Coefficient Adjustments for a DFE-Based Reference Receiver (In support of comments #313 and #314)

Roberto Rodes, Coherent

(Supporting Comments #313 and #314)

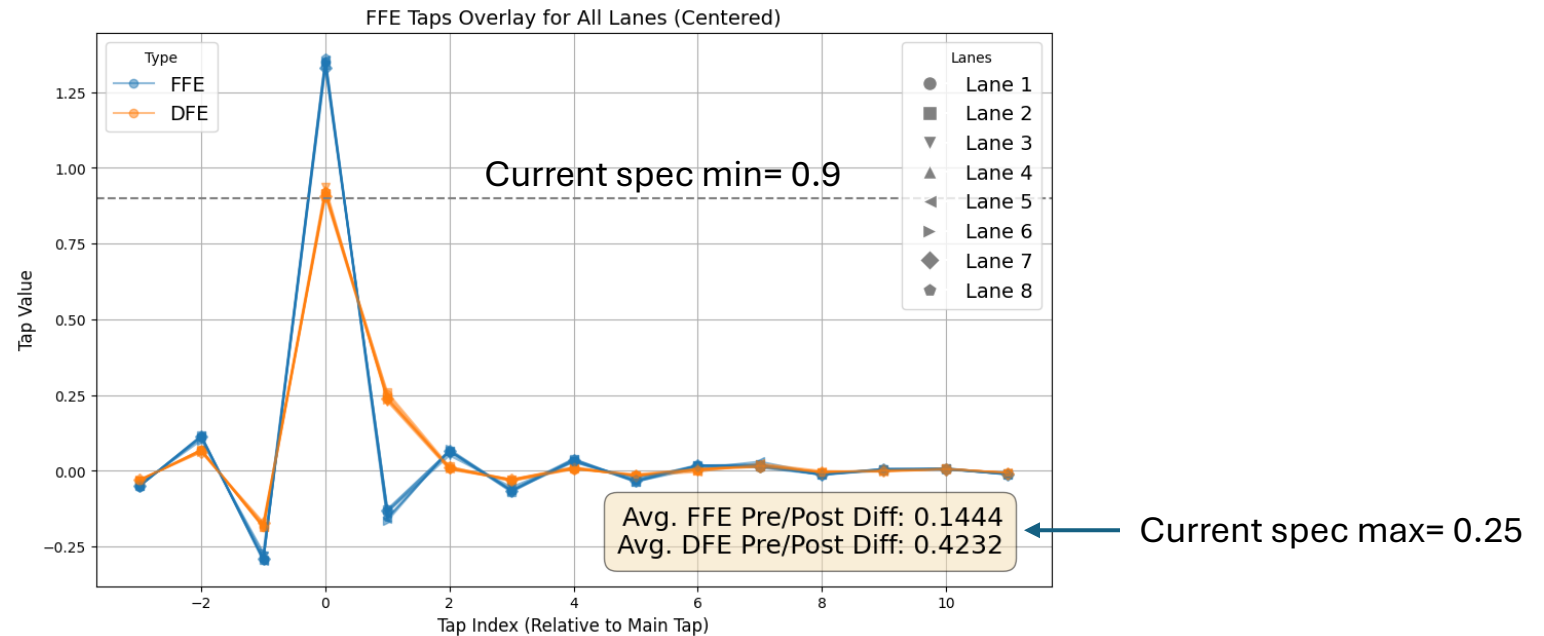
Impact of 1-Tap DFE

With a 1-tap DFE present, the first postcursor coefficient tends to shift toward a more positive value.

- The DFE cancels the intersymbol interference from the previous symbol.
- As a result, the FFE no longer needs to apply strong peaking at the first postcursor.

This impacts two Table 180-15 constraints:

- Minimum main tap value
- Pre-post coefficient difference

Table 180–15—Reference equalizer tap coefficients

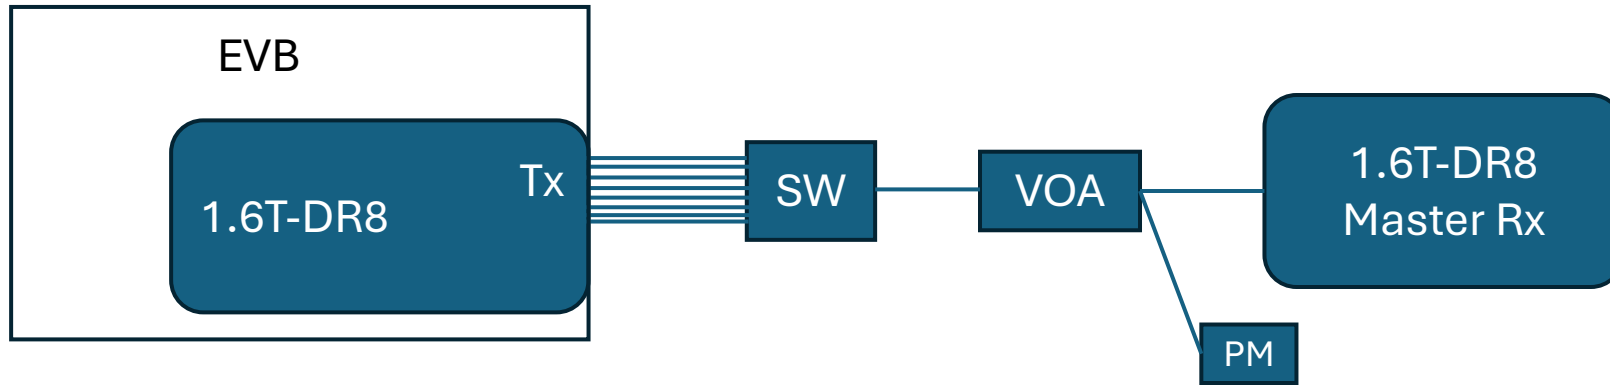
Current Spec:

Main tap min = 0.9

Pre-post difference max = 0.25

Proposed Update:

Main tap min → 0.8

Pre-post difference max → 0.55

TECQ results

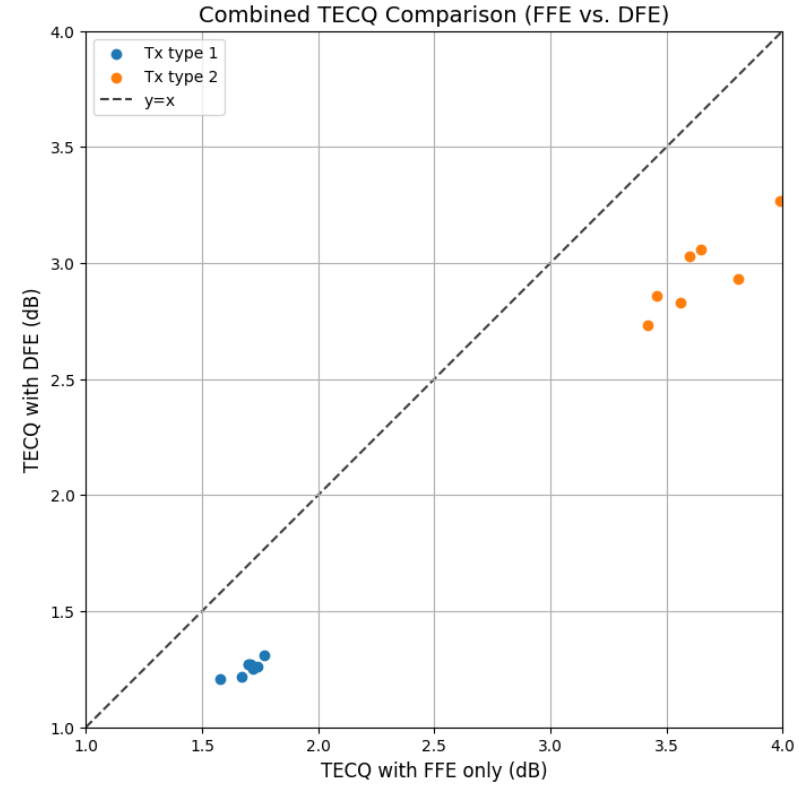
- DFE in reference Rx reduced TECQ value by an average of 0.55dB

Results Rx Sensitivity vs TECQ

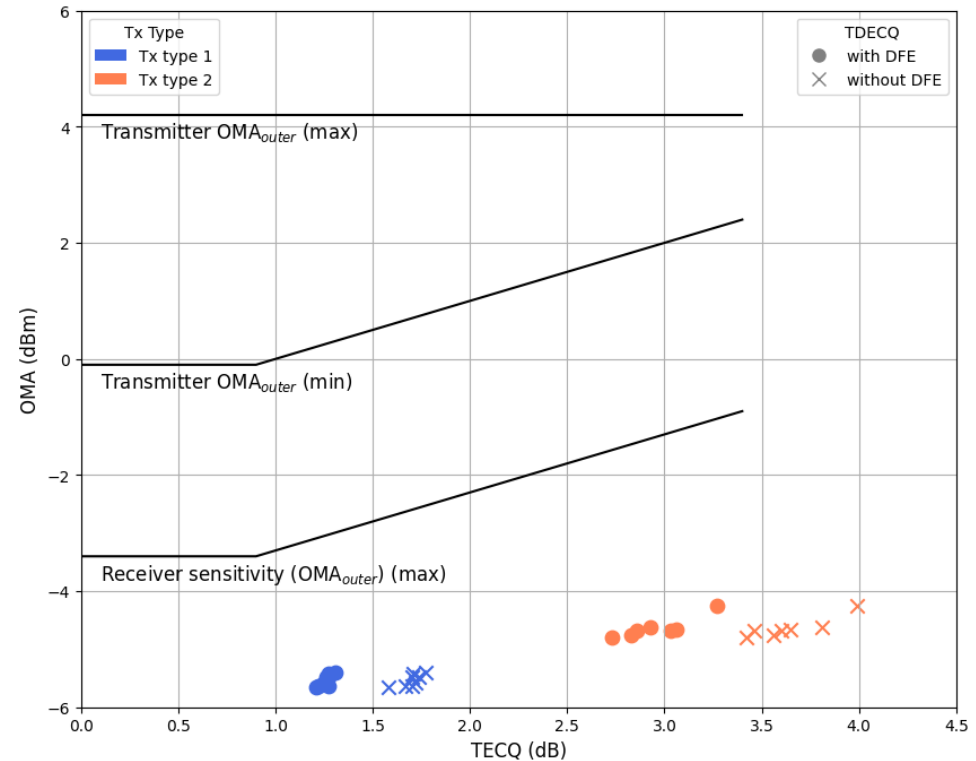
DFE in the reference receiver enable to pass Txs that previously failed

However, these Txs show:

- Good link performance
- Rx sensitivity penalty consistent with TECQ expectations.
